This Addendum forms part of the Tender Documents and amends the Tender Documents as described below.

- 2.1 Revise Project address on cover page and titleblocks to read " 1910 Simcoe St N, Oshawa, Ontario"

SIMCOE VILLAGE RENOVATIONS PHASE 2 - 2019 DURHAM COLLEGE	SCALE	DWG. NO.
CANOPY DETAILS REF DWG A1.1 CANOPY SECTION, DETAILS	AS NOTED	ADD-6
MOFFET & DUNCAN ARCHITECTS INC. 5052 DUNDAS ST. WEST TORONTO ONT. M9A 1B9 TELEPHONE (416)-239-2775	JOB # 1910

17 SECTION @ COUNTER MEETING ROOM 2095
A5.0 SCALE 1:10

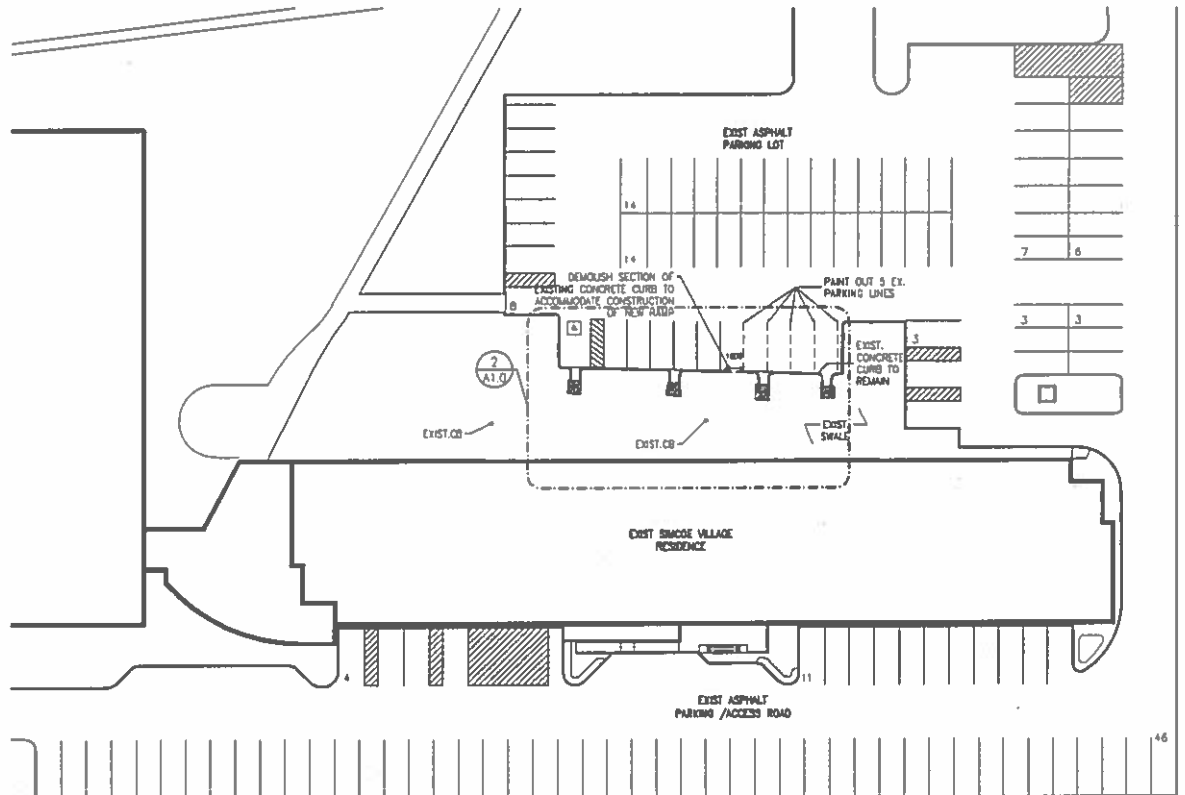
- .1 Delete references to "solid surface countertop" and replace with "quartz countertop".
- .2 Revise Meeting room 2095 kitchenette as per ADD-18.
- .3 Add detail 17/A5.0 as per ADD-19.
- .4 Revise 16/A5.0 Bulkhead in offices as per ADD-21.

SIMCOE VILLAGE RENOVATIONS PHASE 2 - 2019 DURHAM COLLEGE	SCALE 1:100	DWC. NO.
1/A1.0 EXISTING SITE PLAN		ADD-20
MOFFET & DUNCAN ARCHITECTS INC. 5052 DUNDAS ST. WEST TORONTO ONT. M6A 1B9 TELEPHONE (416)-238-2775	JOB # 1910

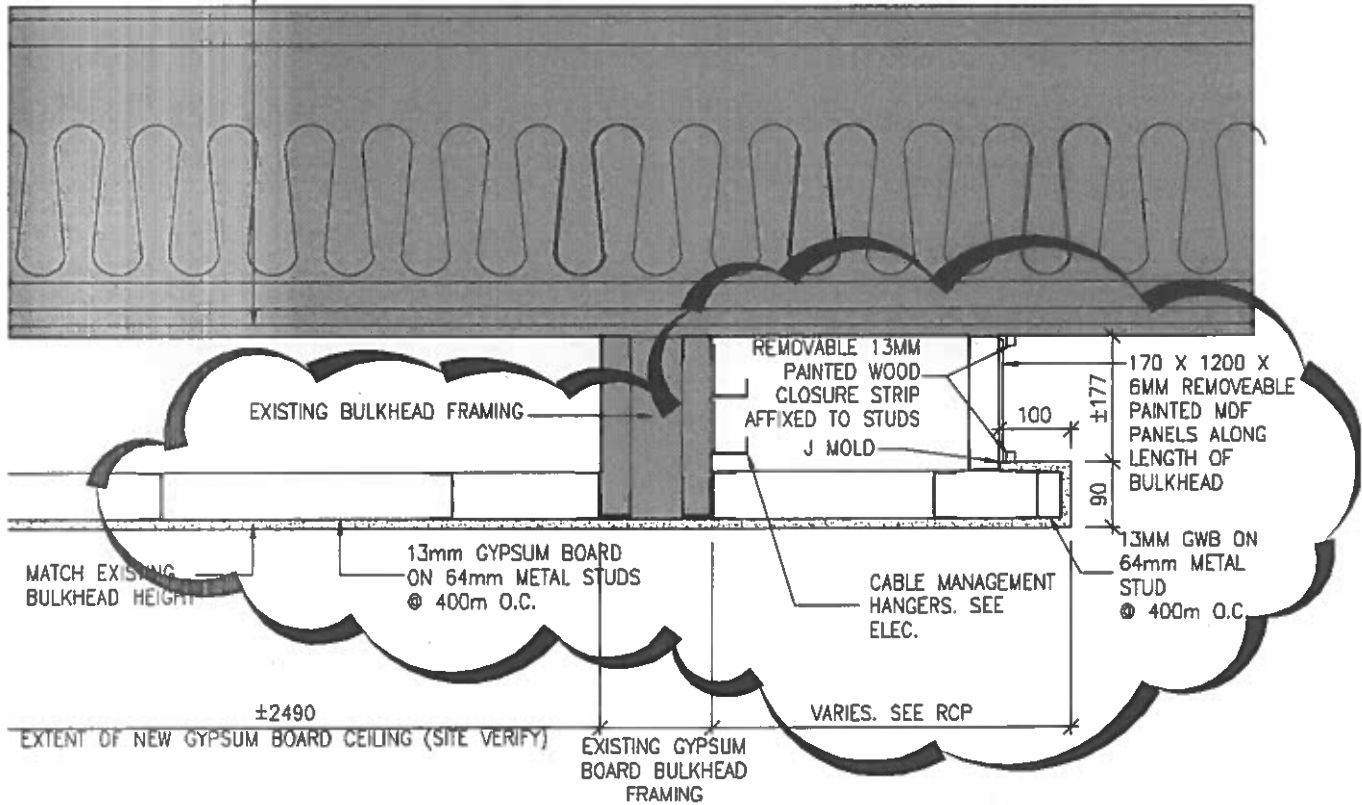
- .1 Revise grading, culvert retaining stones and asphalt walkway on 2/A1.0 as per ADD-1.
- .2 Revise scupper and sloped roofing on top of canopy on 4/A1.0 as per ADD-2.
- .3 Revise height of canopy on 6/A1.0 as per ADD-3.
- .4 Revise guardrail on 6/A1.0 as per ADD-3.
- .5 Replace drawings 1/A1.0 as per ADD-20.

SIMCOE VILLAGE RENOVATIONS PHASE 2 – 2019 DURHAM COLLEGE	SCALE	DWG. NO.
PARTIAL 1/A1.1 CANOPY SECTION	1:10	ADD-4
MOFFET & DUNCAN ARCHITECTS INC. 5052 DUNDAS ST. WEST TORONTO ONT. M9A 1B9 TELEPHONE (416)-239-2775	JOB # 1910

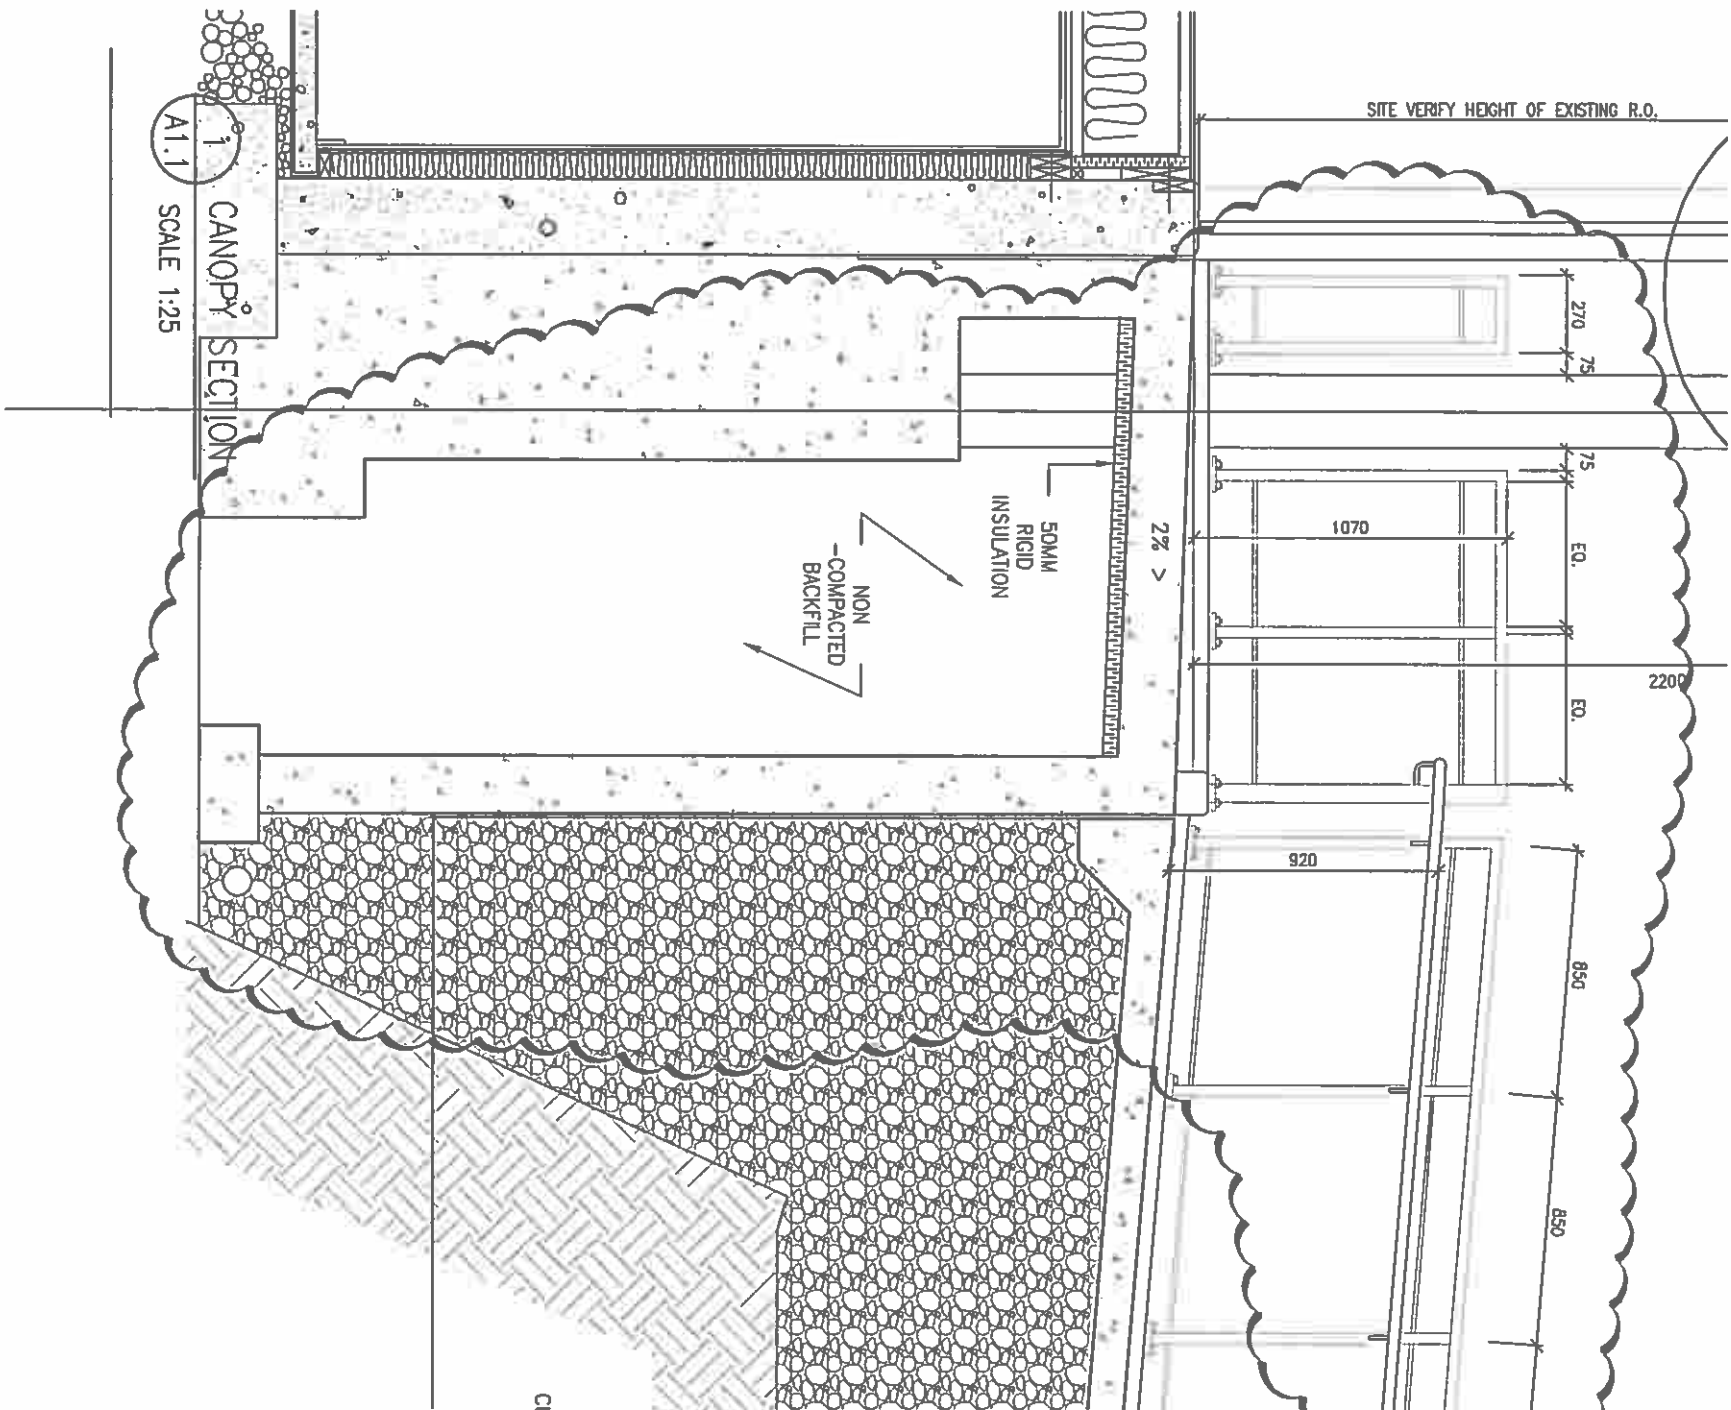
- .1 Revise 1/A1.1 to show insulation and non-compacted fill at new ramp landing as per ADD-4.
- .2 Revise ramp, walkway, guardrail and handrail on 1/A1.1 as per ADD-4.
- .3 Revise 3/A1.1 as per ADD-5.
- .4 Revise 4/A1.1 as per ADD-6.
- .5 Add 5/A1.1 as per ADD-6.
